# LOCAL AREA TRAFFIC MANAGEMENT PLAN – FULLARTON / MYRTLE BANK **RECOMMENDATIONS REPORT**

MARCH 2026

## RECOMMENDATIONS REPORT

### LATM ZONE 5

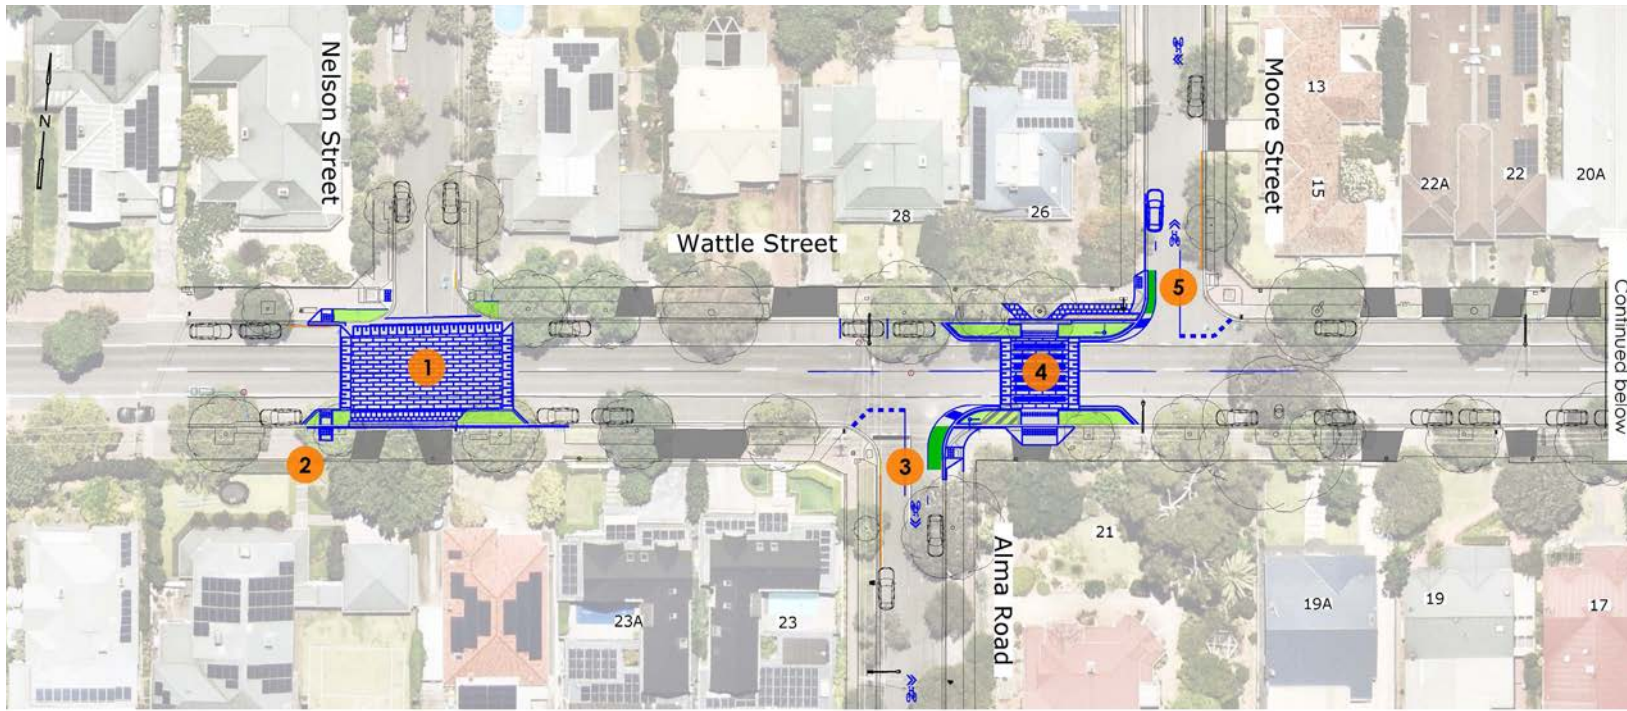
Six comments raised design considerations, with general support for the proposed traffic calming measures and pedestrian crossing, alongside a preference to retain

existing on-street parking. Concerns related to sightlines at Nelson Street, potential light spill from the wombat crossing, cost and suitability of the raised crossing, and possible traffic diversion, with some residents opposite Nelson Street strongly opposing the proposed raised intersection. Some respondents also suggested additional traffic calming on Alma and Wattle Streets and broader network upgrades.

A staged approach to delivery is proposed in response to resident opposition to the proposed raised intersection opposite Nelson Street and concerns about parking loss. Stage 1 would involve installation of the raised priority “wombat” crossing. Stage 2, the raised intersections, would only be considered if post-implementation monitoring shows vehicle speeds exceeding the target 40 km/h and low compliance at the crossing.

No changes were made to the initial proposed concept design, however its delivery is proposed to be staged. The plan is shown on the next page.

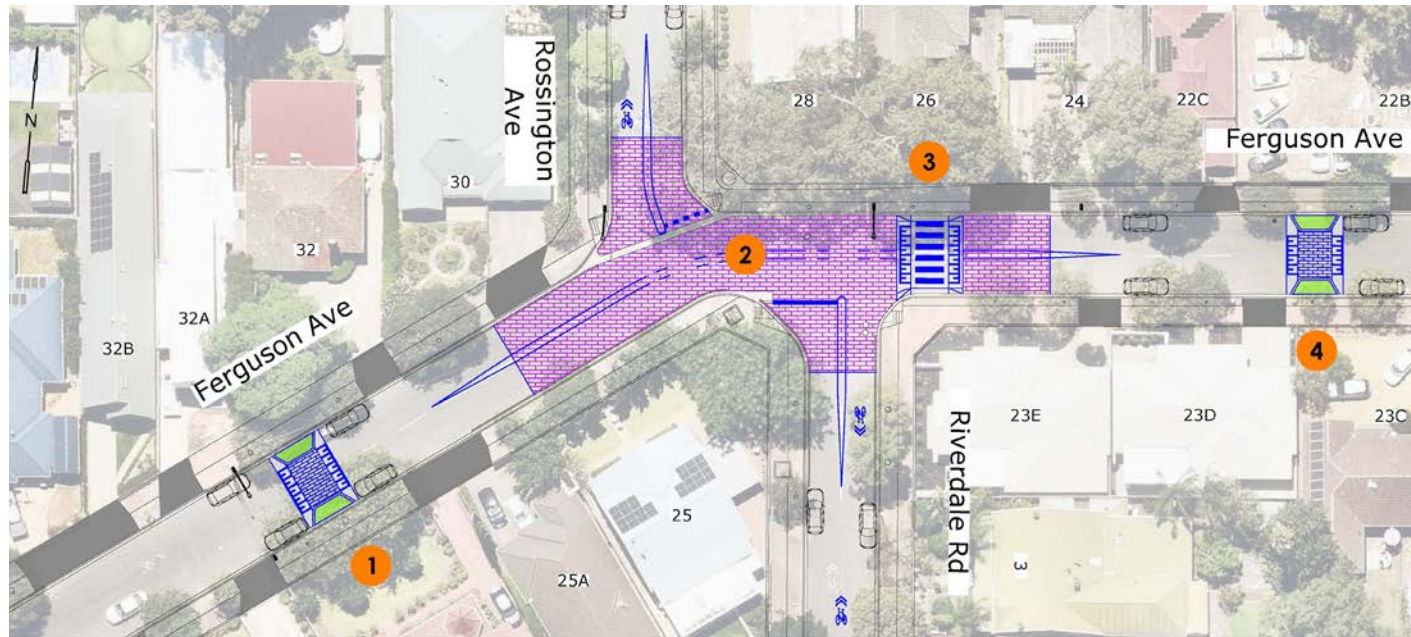
Six comments raised design considerations, including concerns about traffic speeds, safety and rat-running, particularly along Riverdale Road, Rossington Avenue and Ferguson Avenue. While raised street sections and “wombat” crossings were generally supported, some

respondents questioned whether the proposed measures would adequately address blind corners and limited sightlines, and suggested stronger interventions such as movement restrictions, a roundabout or chicane-style treatments. Additional suggestions included broader speed reductions, increased enforcement and managing peak-hour through traffic, with some noting potential cost implications related to drainage works.

Sight lines were reviewed in response to feedback and are considered to be satisfactory. It is acknowledged that the fence on the south–west corner impacts vehicle sight lines for vehicles travelling eastbound; however, the proposed improvements are intended to calm traffic on the approach to the intersection and are expected to improve safety for all road users.

No changes were made to the initial proposed design concept. The plan is shown on the next page.

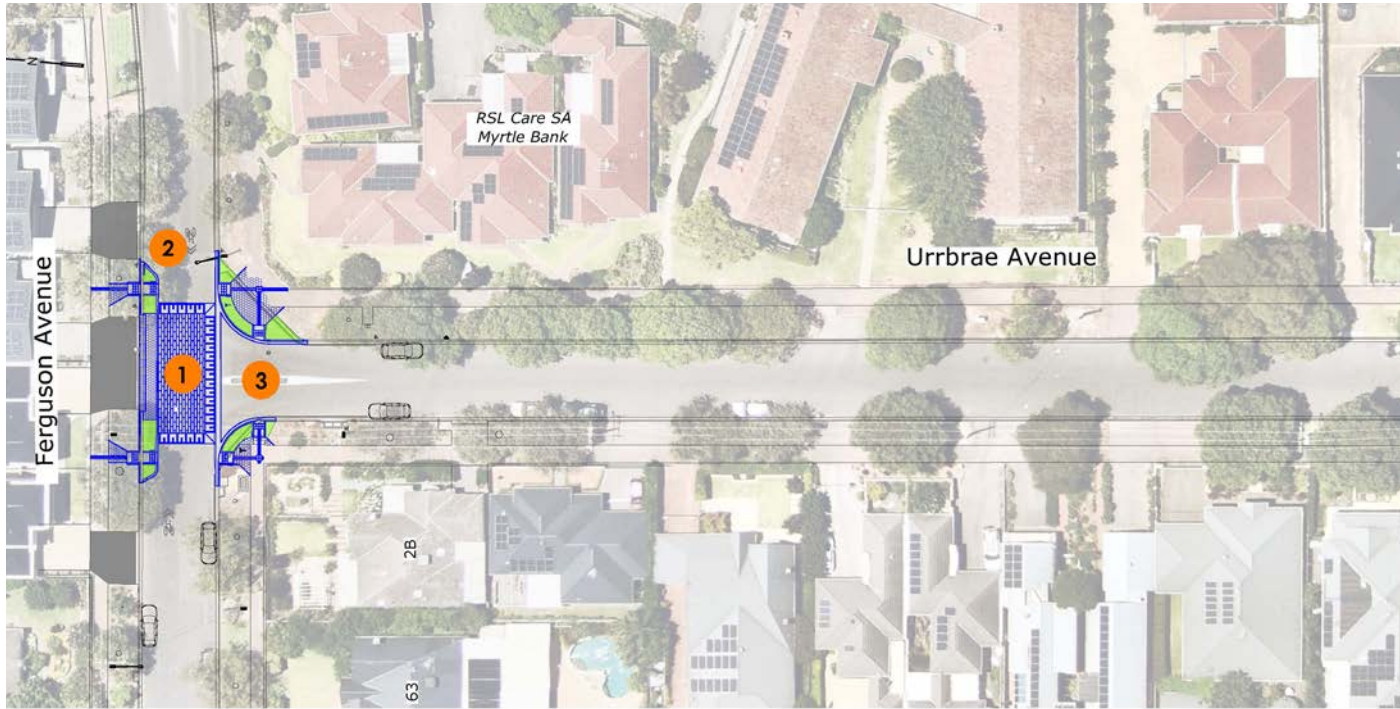
Five comments raised design considerations. While the proposed traffic calming measures were generally supported, some respondents expressed concerns about the cost and visibility impacts of raised pavements, landscaped kerb extensions and contrasting treatments. It was also noted that existing verge plantings and

A number of residents raised concerns about the number of U-turns occurring at the Urrbrae Avenue and Cross Road junction, which were attributed to the lack of traffic signals at the Waite Road junction (within the City of Mitcham).

Peak-period surveys (7:00–10:00 am and 3:00–6:00 pm) recorded 22 U-turns in the morning peak and 42 in the afternoon, with right-turn volumes of 67 in/17 out (AM) and 108 in/25 out (PM), and some vehicles completing U-turns within Urrbrae Avenue. While U-turn activity is evident, restricting this movement may shift traffic into Urrbrae Avenue for three-point turns and would require further consultation and DIT approval before any change is considered. Further design testing indicates that a small physical median could be implemented at this location, subject to support from the local community and DIT.

**No changes were made to the initial proposed concept design, however an addition of a central median at Urrbrae Avenue junction with Cross Road will be considered in consultation with the local community and DIT. The plan is shown on the next page.**

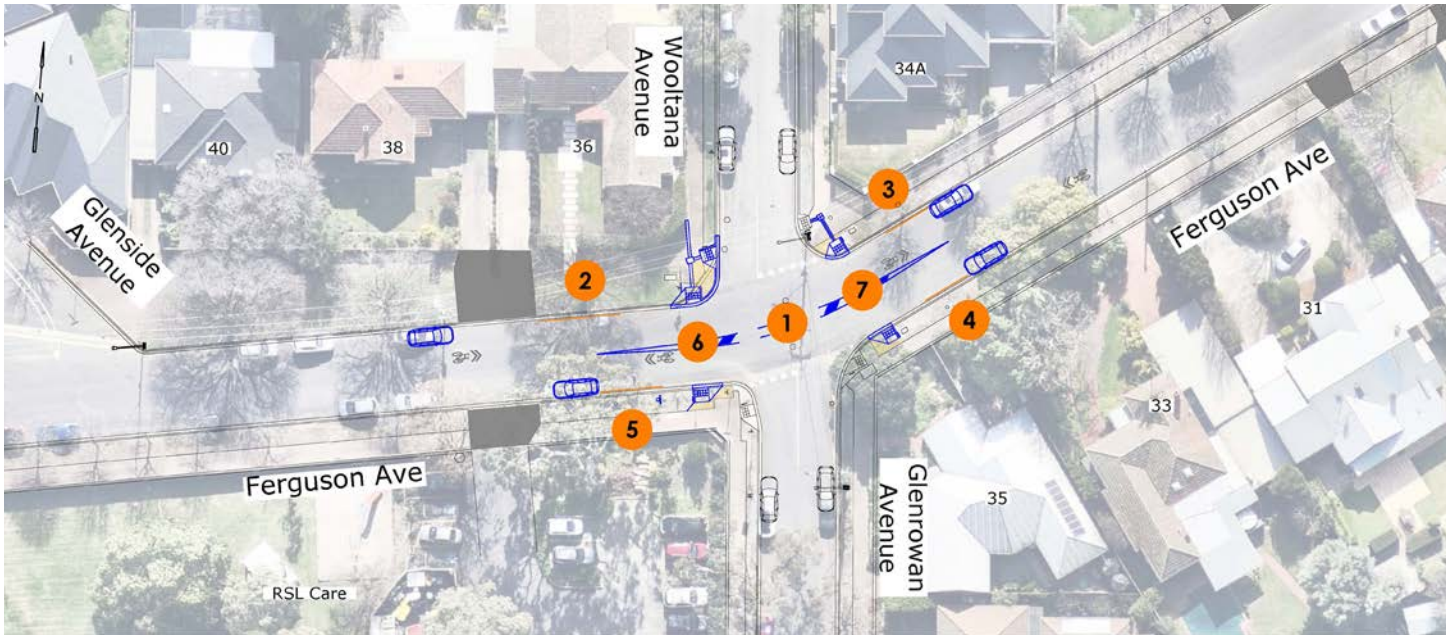
A total of 35 comments were received for this recommendation. The largest share of comments related to design considerations, particularly around proposed parking restrictions and improvements to pedestrian facilities. Notably, the number of comments expressing support for the recommendation was equal to those raising design considerations.

Eleven comments raised design considerations. While the proposed improvements were generally supported, respondents highlighted the need for stronger parking controls and improved pedestrian facilities, including a crossing and kerb ramps, to address accessibility and safety concerns. Issues with sightlines near Wooltana Avenue and parking associated with the nearby RSL

Based on community feedback, design testing was undertaken to assess whether new north-south kerb ramps could be accommodated at the intersection. This was able to be achieved without the removal of any additional on-street parking beyond the four spaces already proposed as part of the original design.

Minor changes were made to the initial proposed design concept. The updated plan is shown on the next page.
